YANKEE ATOMIC ELECTRIC COMPANY

REQUEST FOR ADDITIONAL INFORMATION

YANKEE NUCLEAR POWER STATION (YANKEE ROWE)

DOCKET NO. 50-29

FIGURE 16.3.2-1
CORE XII SAFETY LIMIT CURVES FOR
4-LOOP OPERATION

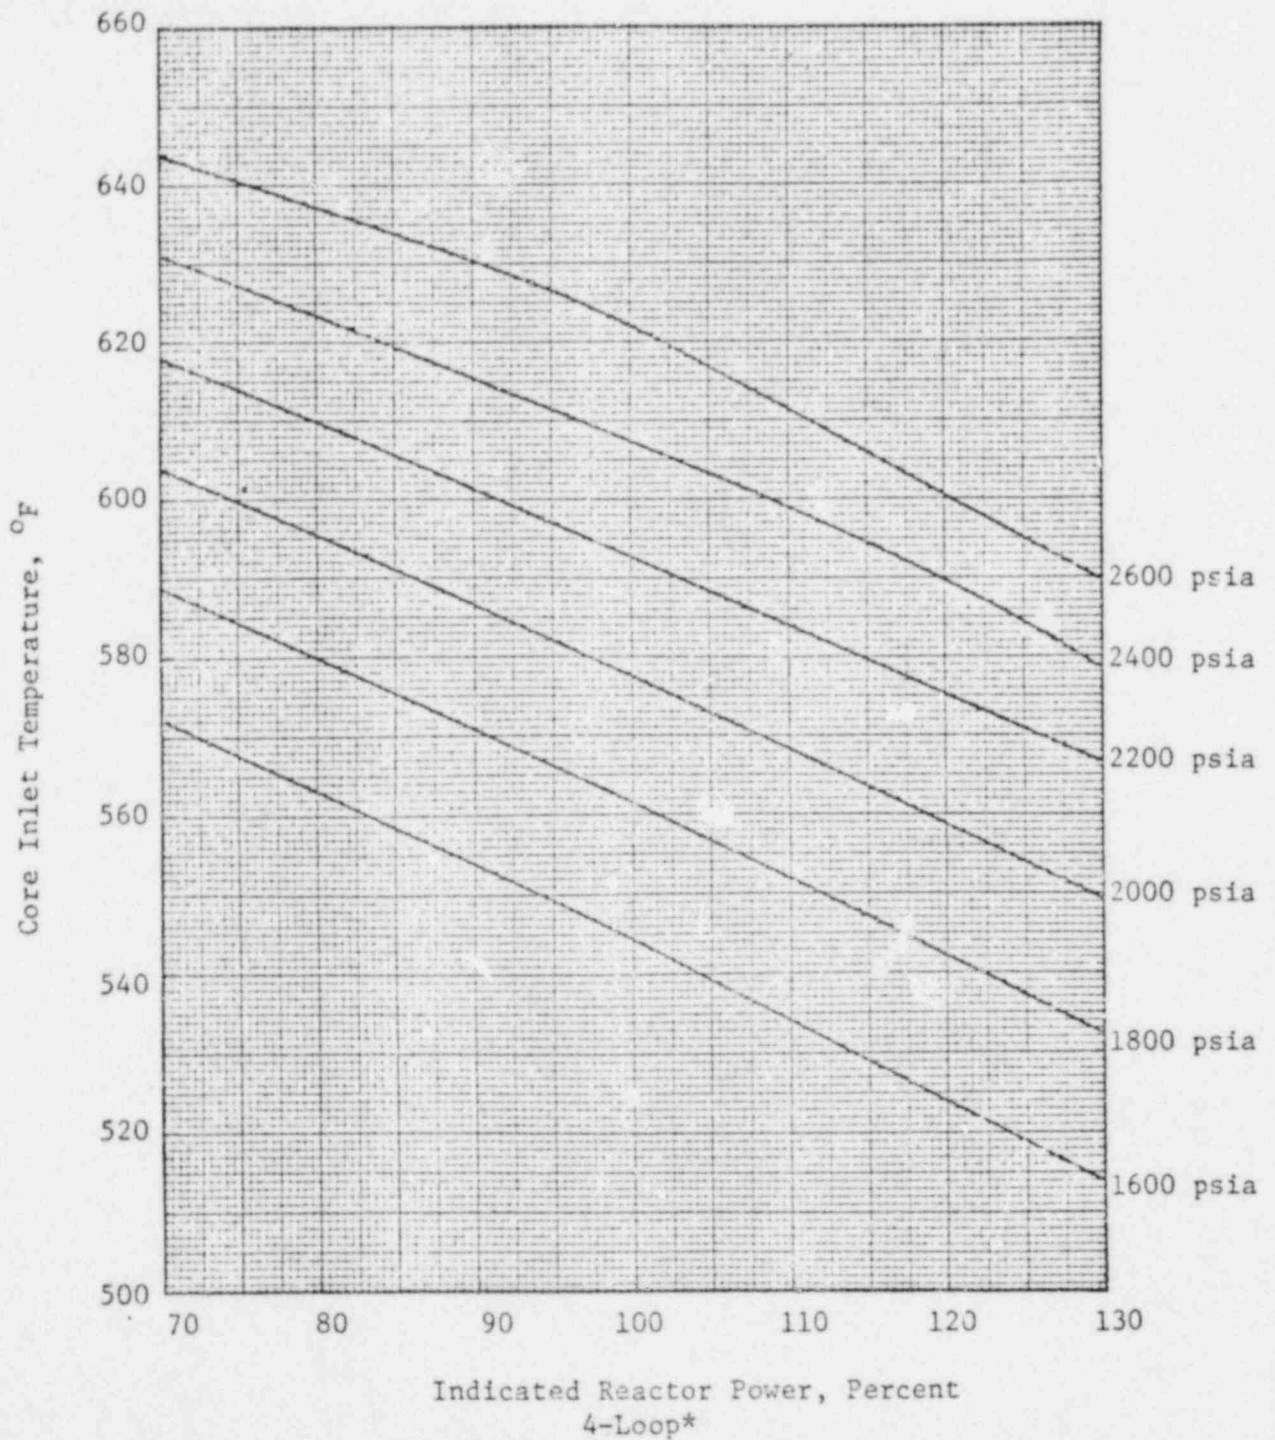
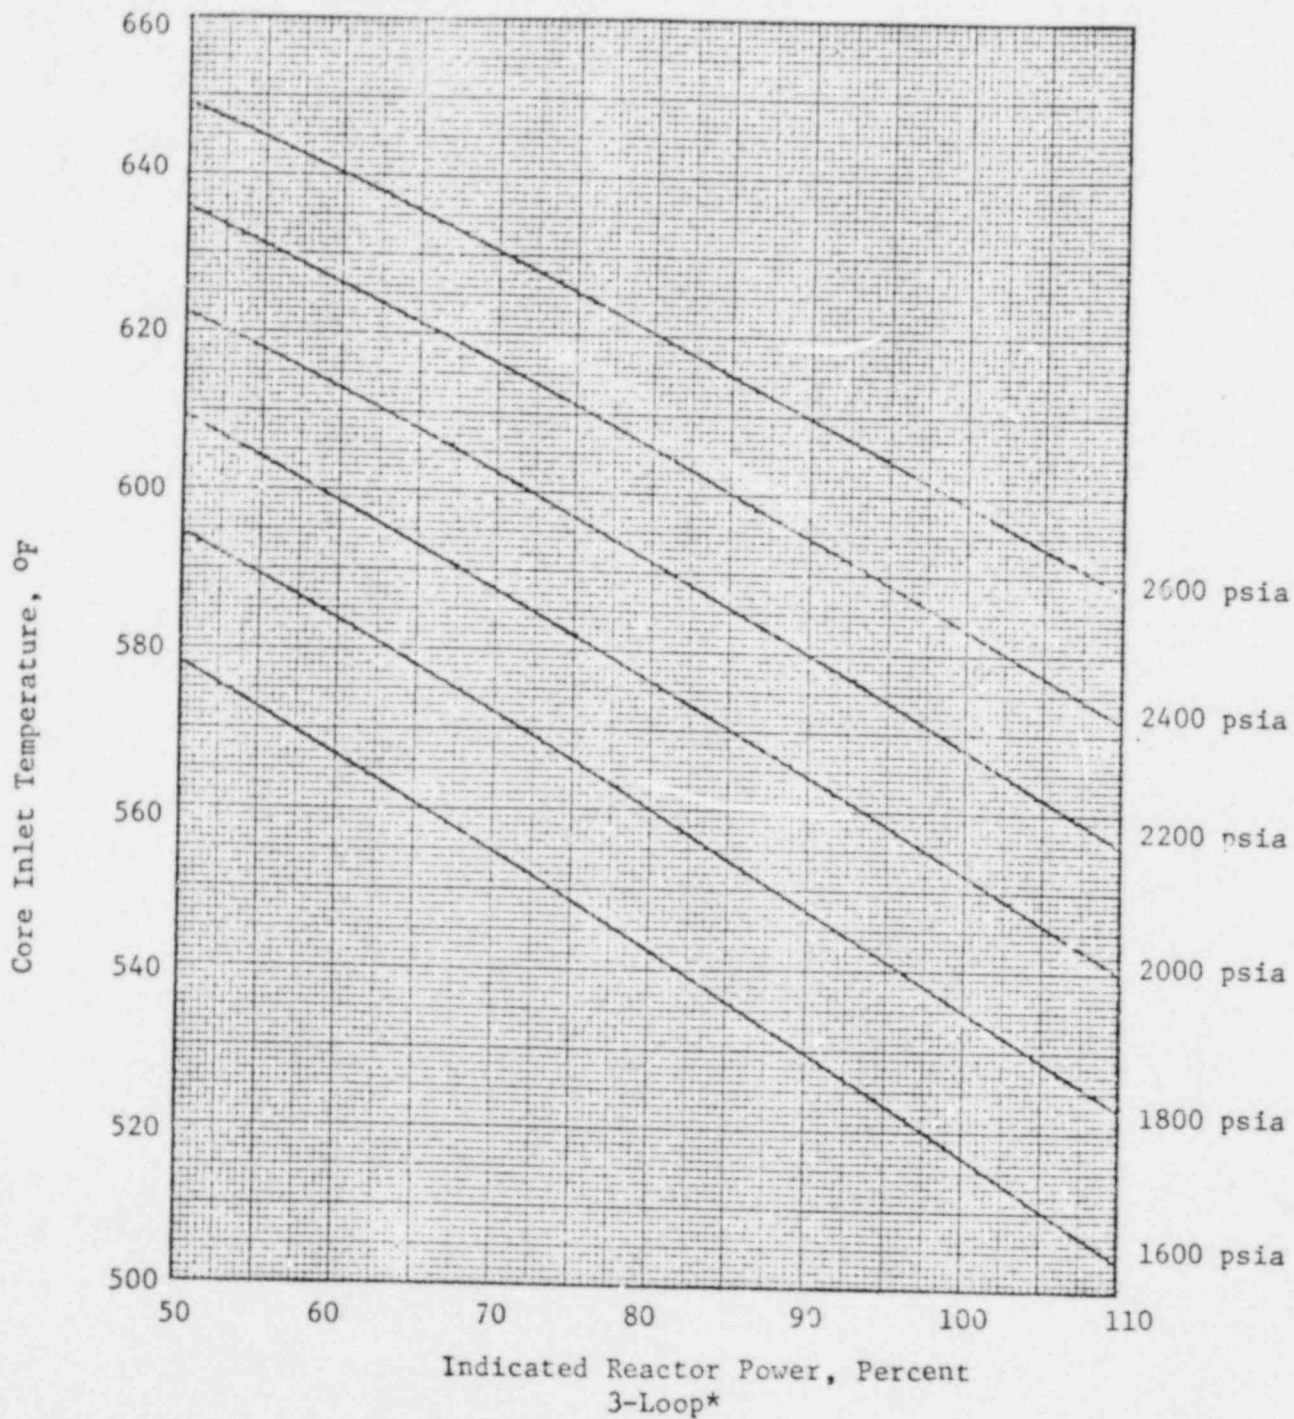
The proposed "Safety Limits-Reactor Core" in Specification 16.3.2 are no longer applicable. Revise this specification and its associated basis to reflect the conditions analyzed by you and approved by us for the operating Yankee-Rowe core.

Specification 16.3.2 has been revised to reflect the conditions of Core XII to be inserted in October 1975. Details of this Core were submitted in reference 5.

Specification: The reactor power level shall not exceed the allowable limit for the pressurizer pressure and the reactor coolant system cold leg temperatures, shown in Figures 16.3.2-1 and 16.3.2-2 for 4 and 3 loop operation respectively.

FIGURE 16.4.8-1

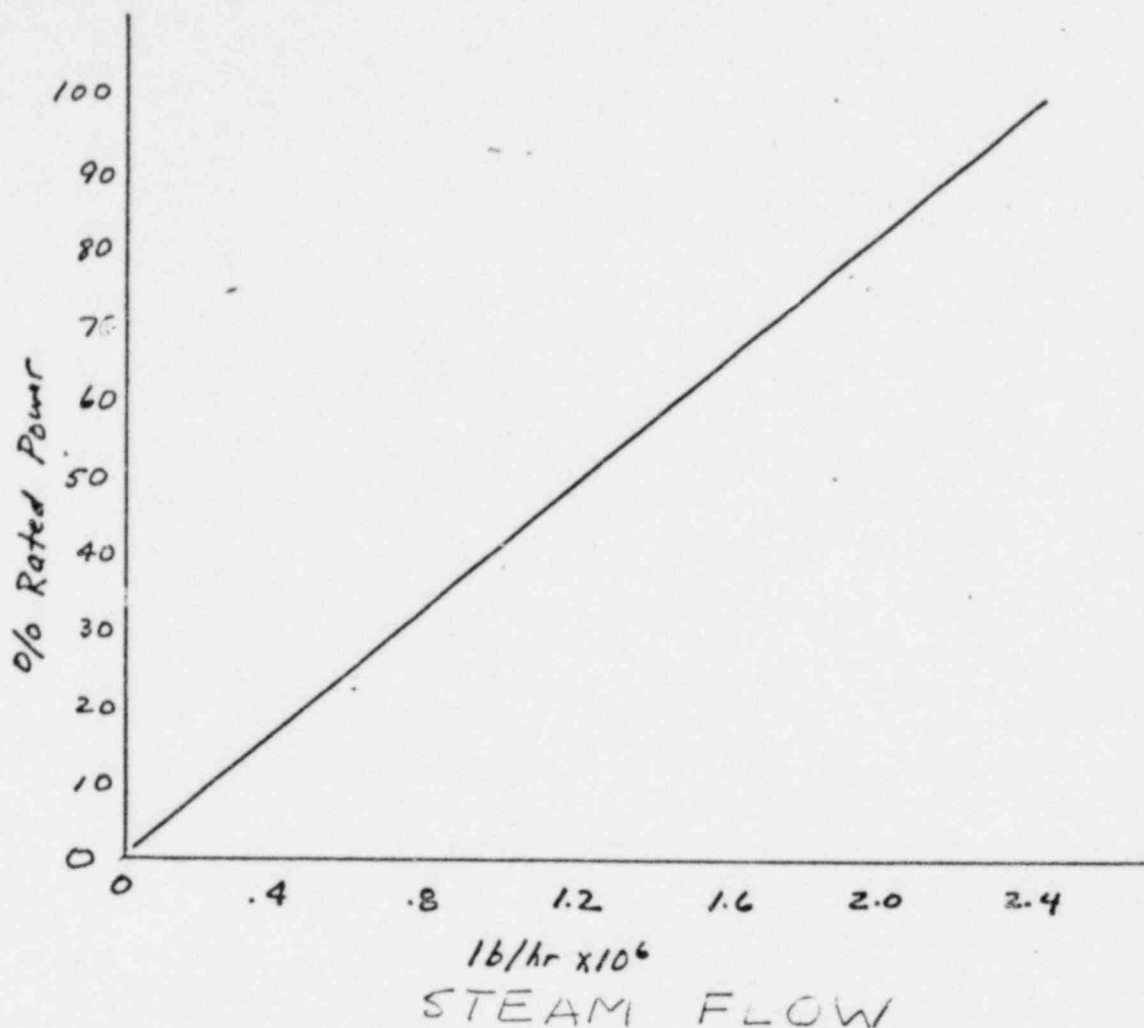
Specification 16.4.8 "Reactor Core Energy Removal" includes requirements that the reactor shall not be at power unless a minimum steam relieving capacity of 1,000,000 lbs/hr is available above 10% of full rated power and a minimum steam relieving capacity of 1,900,000 lbs/hr is available above 75% full rated power. The number of on-line safety valves providing these steam relieving capacities should be specified. The explicit basis to show that these relieving capacities are adequate to maintain the pressure in the turbine cycle components within allowable limits of the ASME Code should be given.

Specification 16.4.8 Reactor Core Energy Removal has been revised to include figure 16.4.8-1 that prescribes the minimum steam generator safety valve relieving capacity versus percent of rated power. Revised Specification 16.4.8 is attached.

C. The reactor shall not be in a power operation condition which generates steam at a rate in excess of the on-line steam generator relieving capacity in accordance with Figure 16.4.8-1.
